CONSERVATION COMMISSION AGENDA

Date: Tuesday, December 20, 2022

2. 7:20 – 37 Truman Rd – NOI – demo/construction of SFH -- DEP #239-944

65 Harwich Rd - approved plan at time of COC.

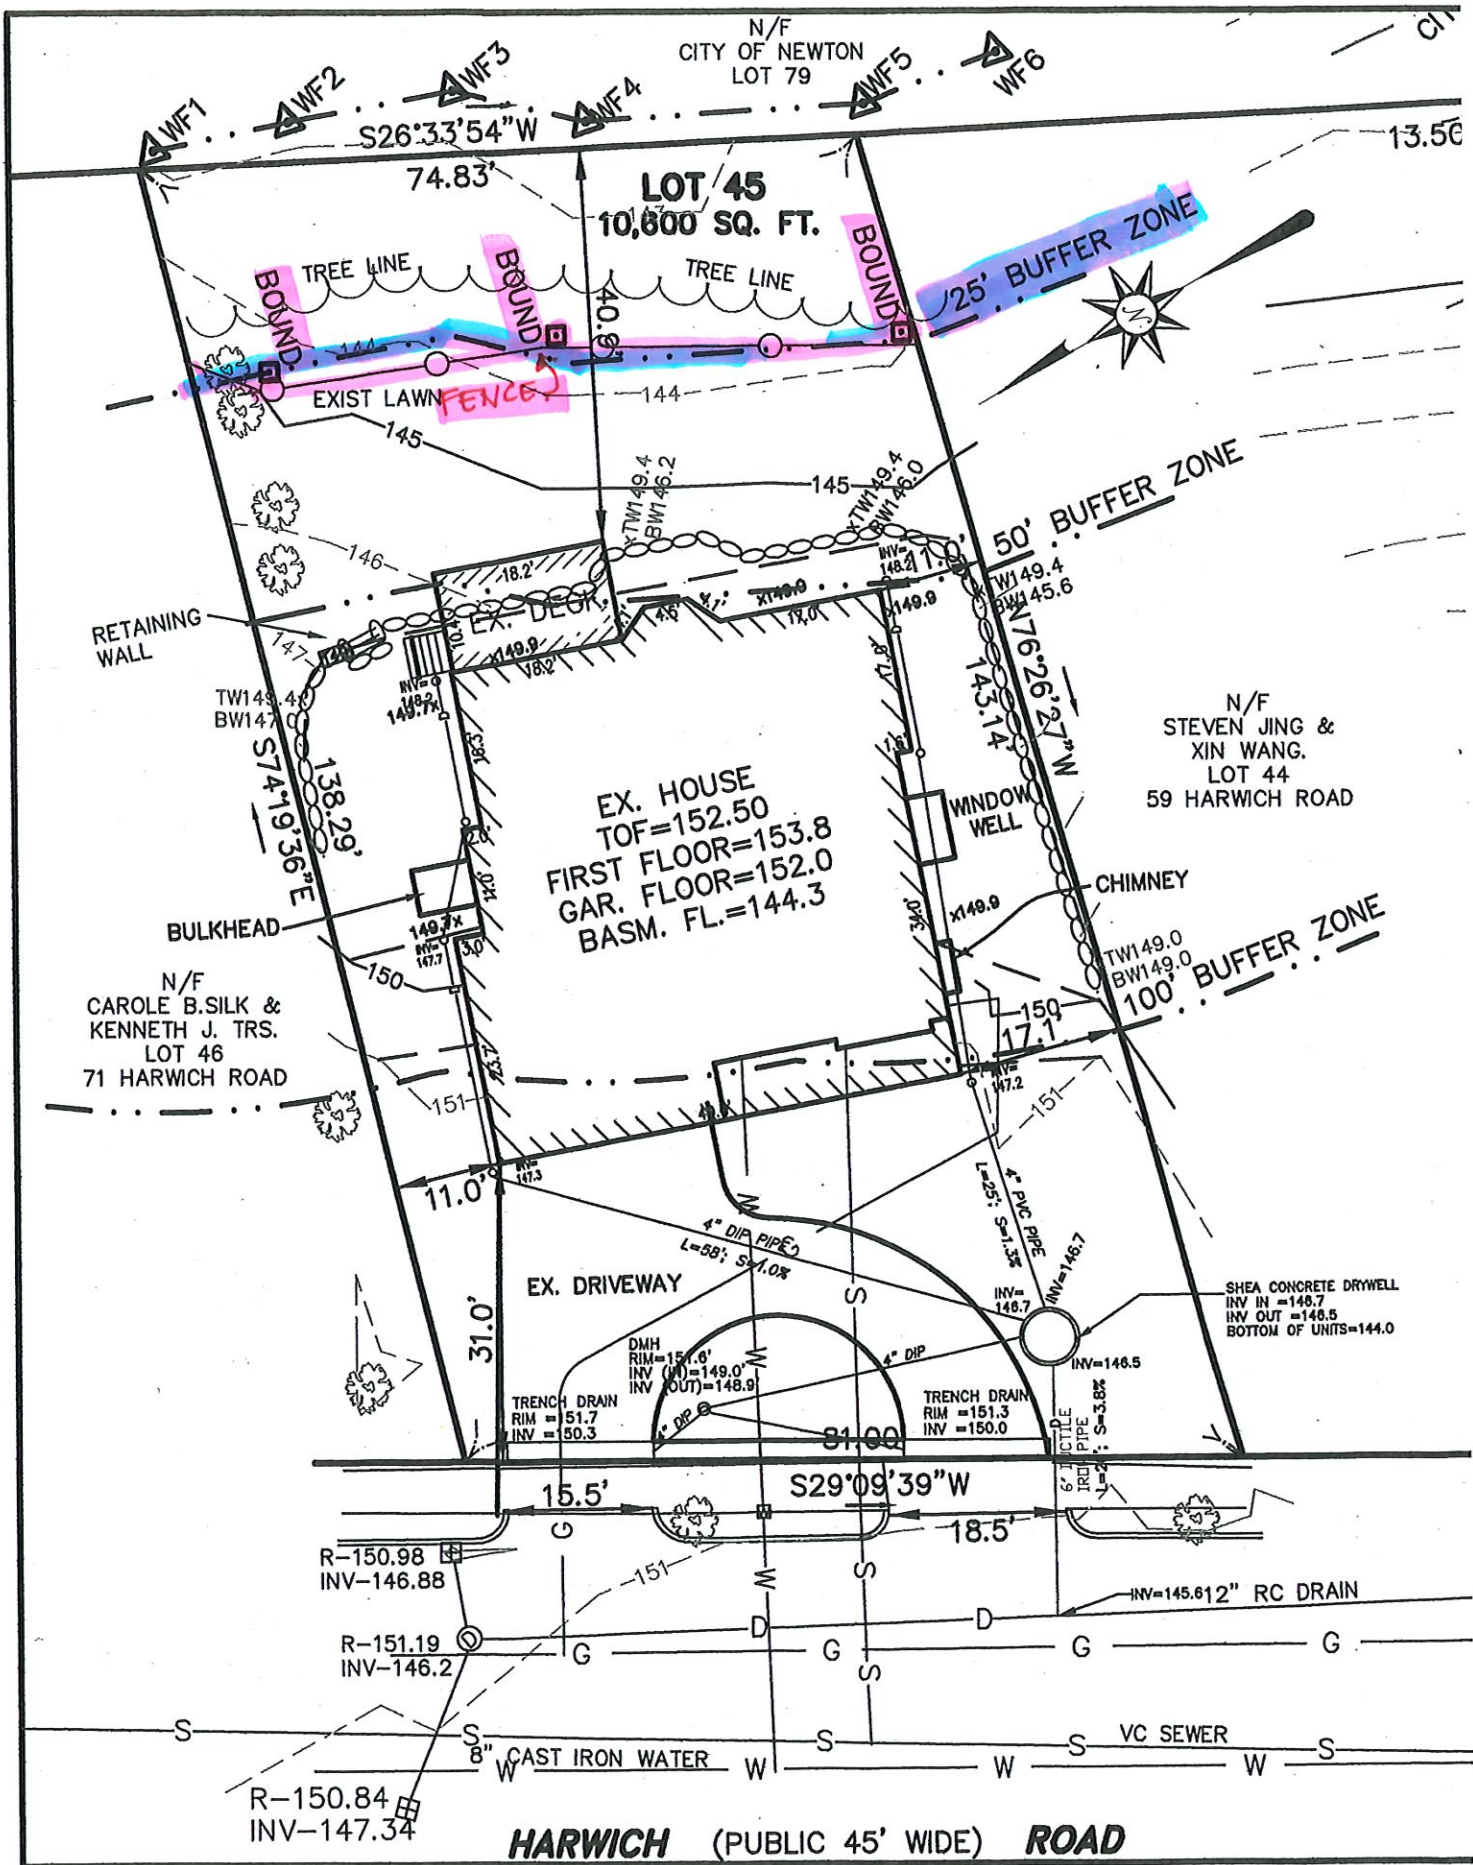
- Staff Notes.
 - Staff confirmed that: (1) the mature trees that were due to have been preserved were preserved, (2) the fence required in the Order of Conditions has been removed, and (3) lawn has been extended into what was due to have been the protected 25' Naturally Vegetated Buffer.

- Staff have not been able to access the back yard to confirm the presence of the bounds shown on the as-built plan.
 - The owner has indicated that they would like to consider alternatives to the original required fence and bounds.

- If a new plan is proposed, it should be noted that the wetland line from the original filing

was not confirmed with soil samples and so the wetland line may, in fact, be closer to the house than shown on the old plan, and so may alter the Commission's assessment of the 25' Naturally Vegetated Buffer.

- Staff Recommendation.
 - Once an appropriate rectification plan has been provided and approved, staff recommend issuing an Enforcement Order to ensure that approved remedial work will be completed.

37 Truman Rd - 27 trees and 56 shrubs are proposed.

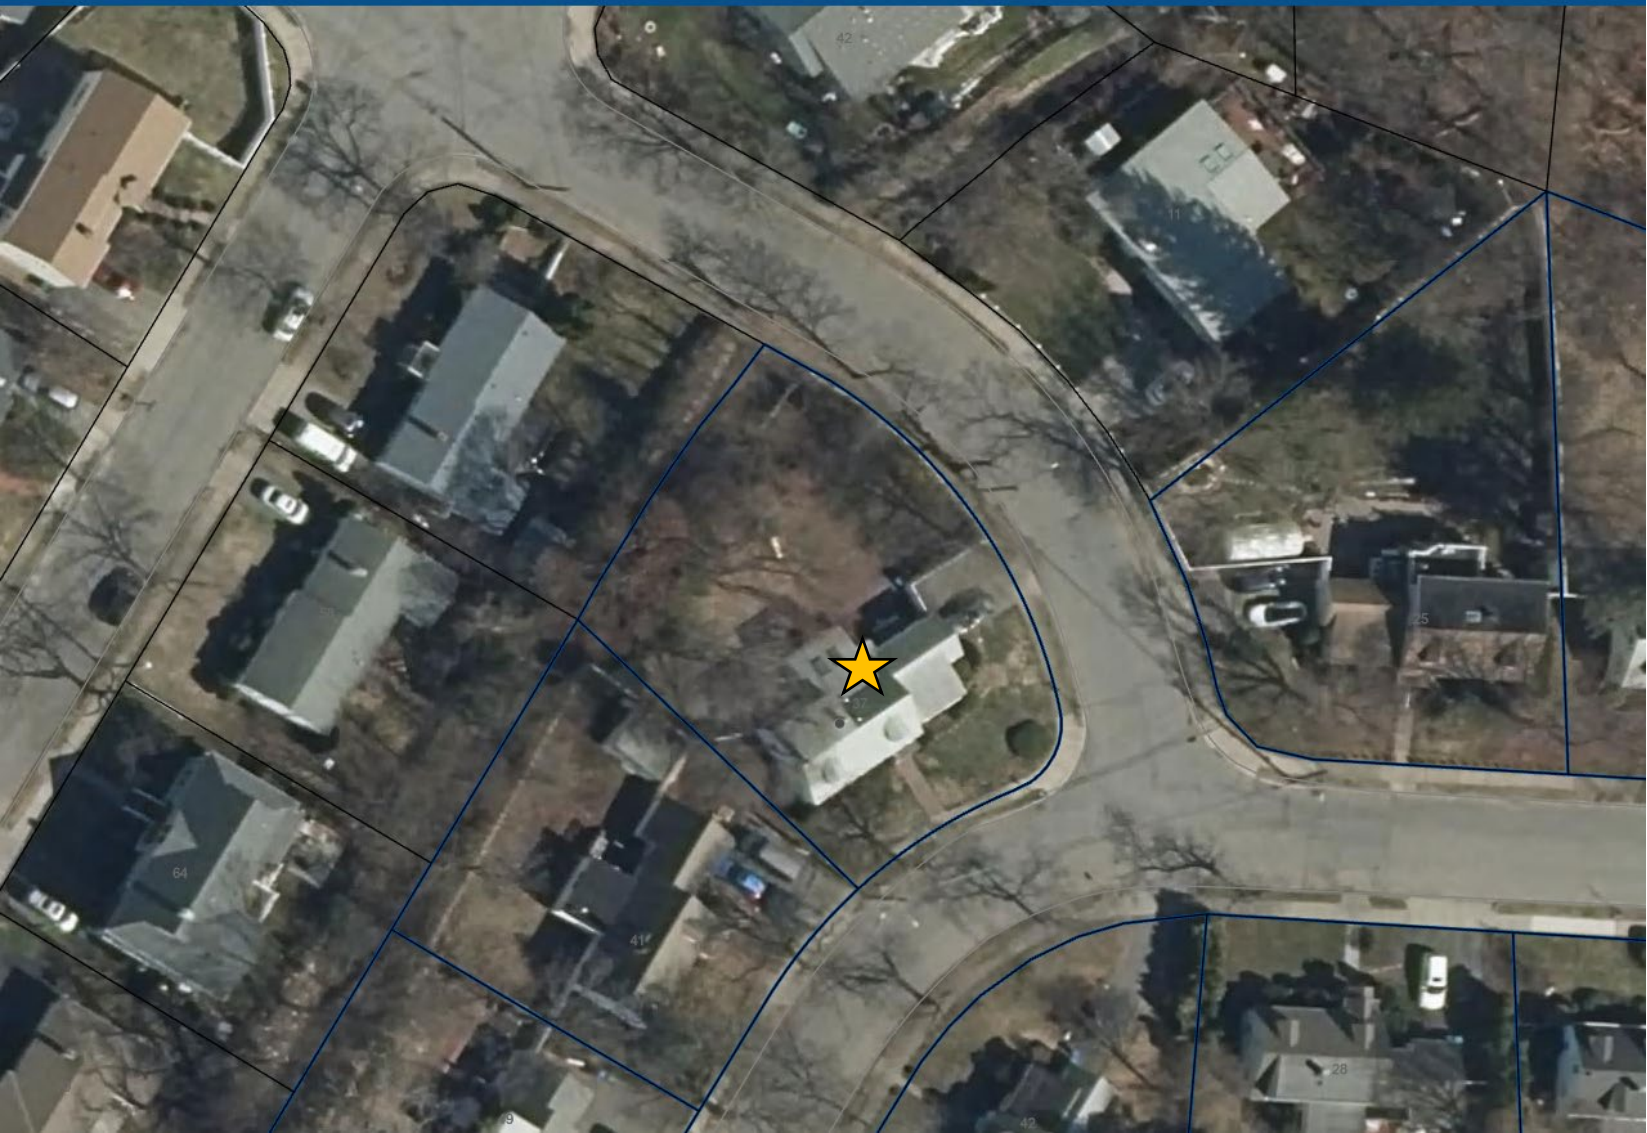
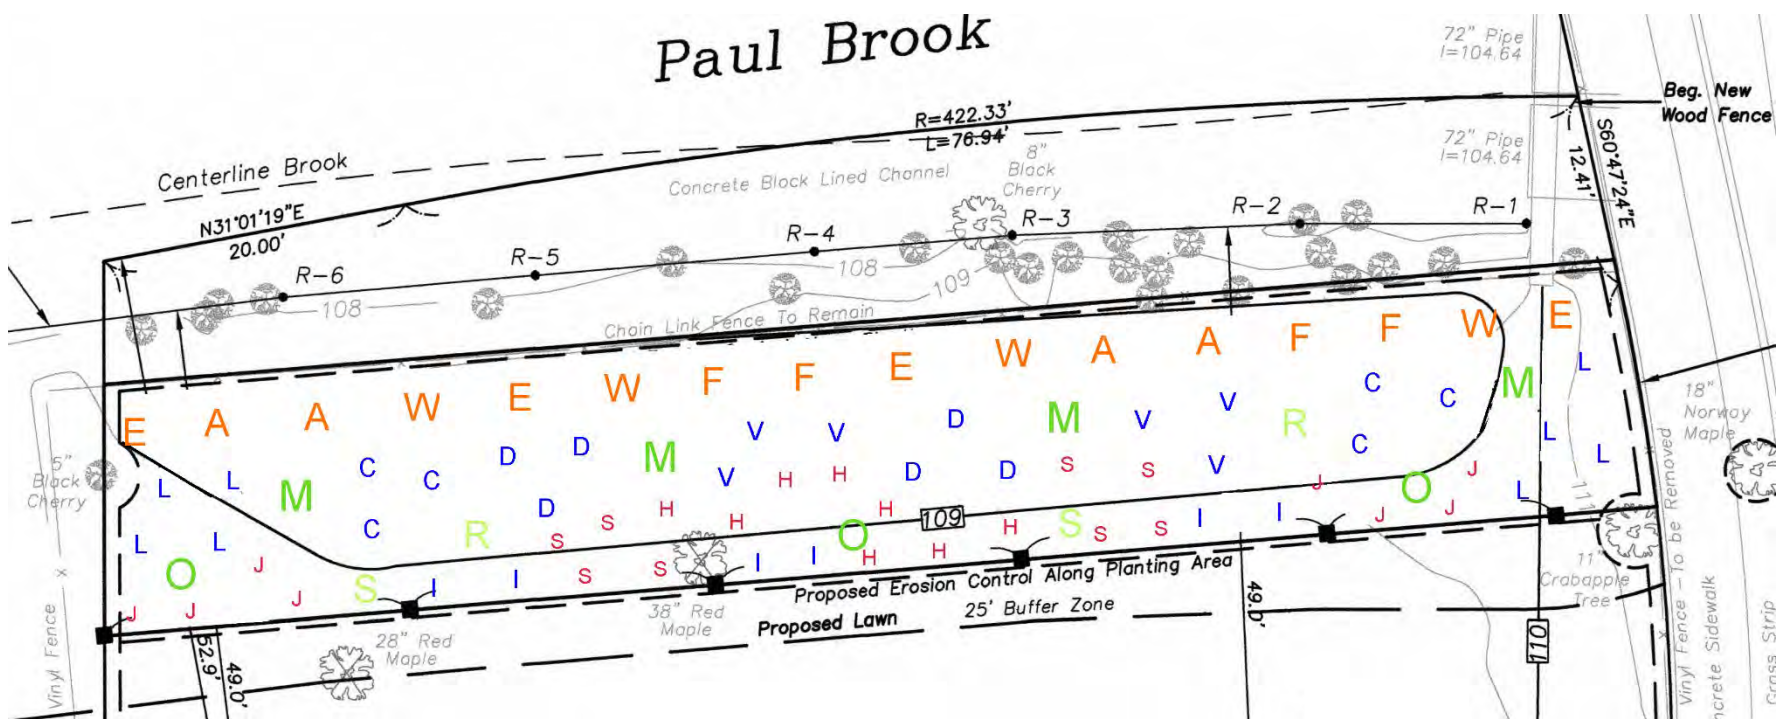
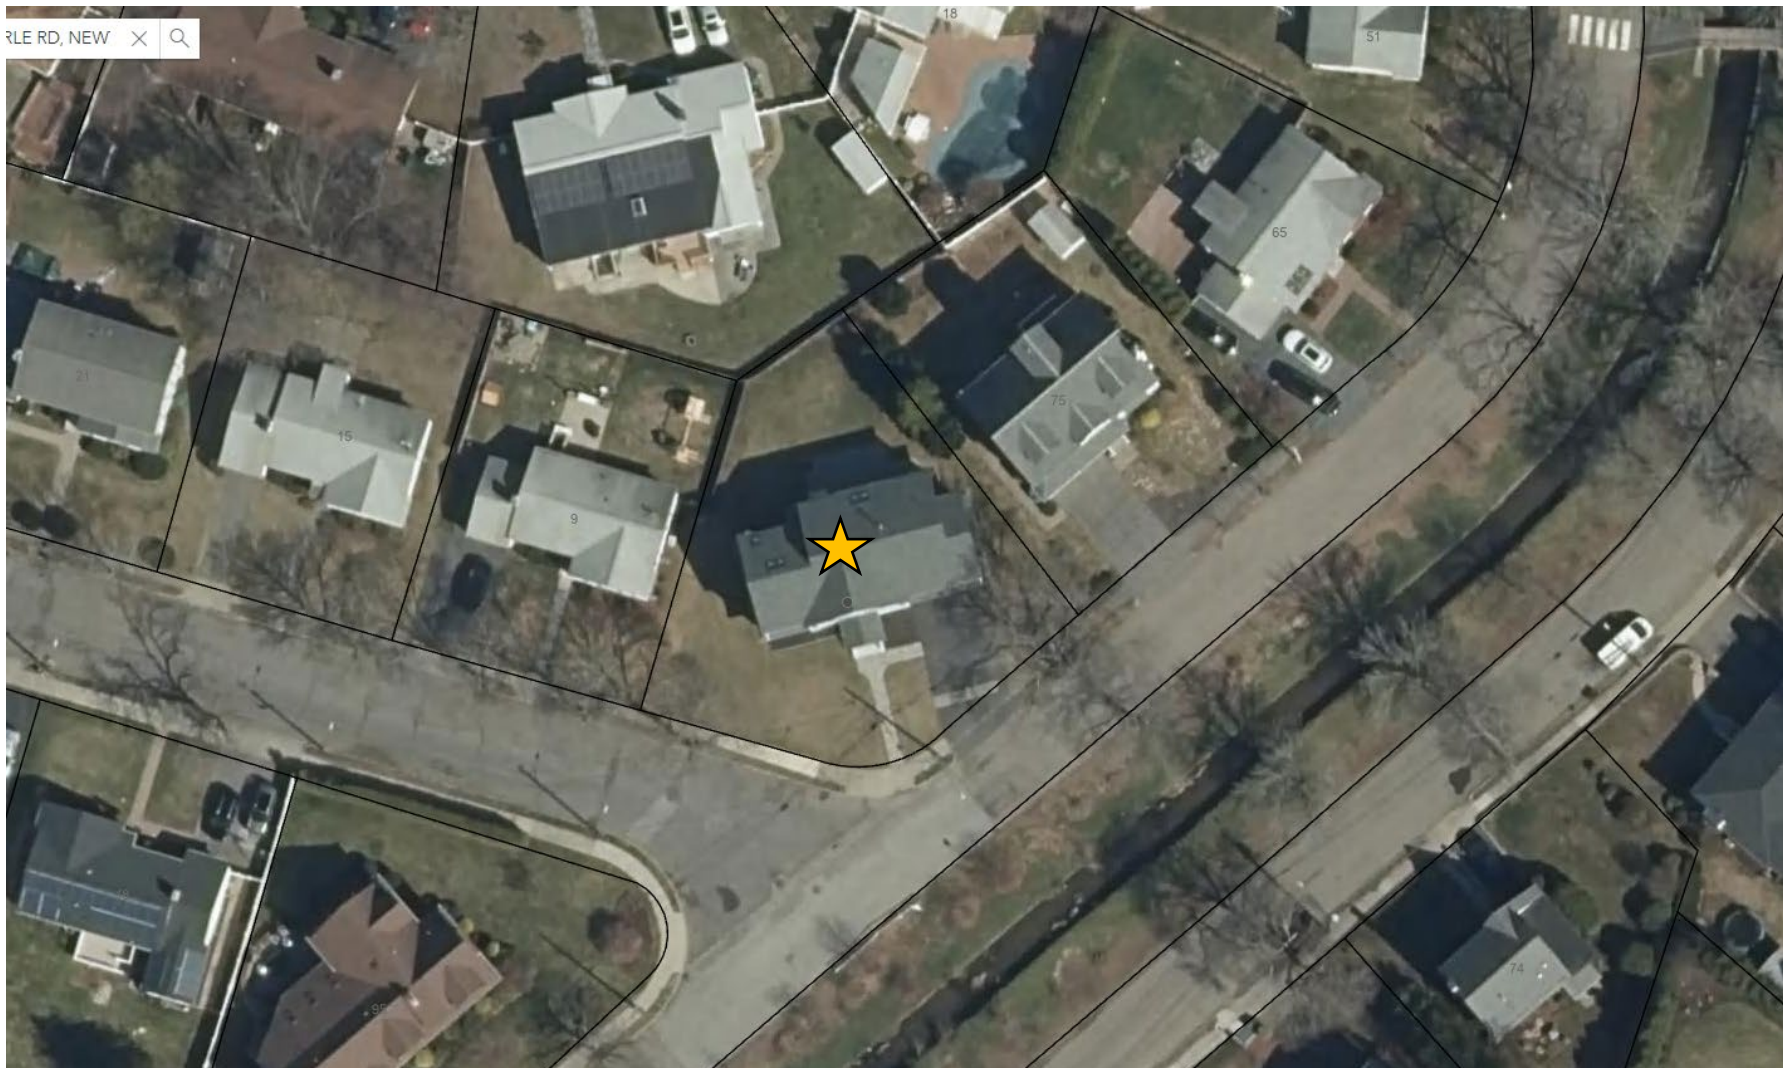
- According to 310 CMR 10.58(5), this project must:
 - (a) result in an improvement over existing conditions – Staff feel that the Commission should consider greater tree preservation

- (b) manage stormwater according to standards – true/done
- (c) work shall not be closer to the river than existing – the patio is a bit closer and so should be reconfigured.
- (d) work...shall be located... away from the river – true/done
- (e) work shall not exceed the ... degraded area ... except with restoration of at least 1:1 or mitigation of at least 2:1 – Staff were just made aware of DEP’s interpretation that conversion of impervious areas to lawn canNOT count as “restoration” or “mitigation”. Staff feel that the mitigation planting plan does not sufficiently mitigate for the proposed removal of trees AND the expansion of the degraded area.
- (h) If there is restoration or mitigation, there must be a continuing condition in the OOC and COC prohibiting further alteration within the restoration or mitigation area.

- The plan proposes to protect 2 trees. -- Staff feel that the tree protection illustrated on the plans is not sufficient to provide real protection and should be expanded.
- The plan proposes to remove 4 large deciduous canopy trees (totaling 115”), 8 hemlocks (totaling 49”), and 2 dead hemlocks. An arborist’s report indicates that all these trees are “failing”. -- Staff feel that some of the 4 large deciduous canopy trees slated for removal are contributing significant value as canopy and habitat and could/should be protected. This could be accomplished by moving the infiltration system to the northeast and adjusting the proposed grading.
- The proposed planting area is 20’ wide. -- Staff note that this does not protect the full 25’ of the Commission’s desired Naturally Vegetated Buffer.

- The Details Sheet should be amended to include a title for the leaching galley.
- Stormwater is due to be addressed with two leaching galleys fed by drain lines.

- Staff have concerns that the proposed infiltration/leaching system could be in groundwater.
 - The bottom of the stream channel (culvert invert) is 104.6.

- Usually ground water is above the elevation of an adjacent stream.
 - Test pit data doesn't note the elevation of any mottling.
 - Their ESHGW is a foot or two above observed water, but is well below the stream channel bottom.

- Test pit data doesn't note the date of the test or the licensed soil evaluator. We are in the season of especially low groundwater AND in a severe drought (down over 12" for the year).

- Staff Recommendation. Seek plan modifications that resolve the concerns above and any others raised at the hearing.
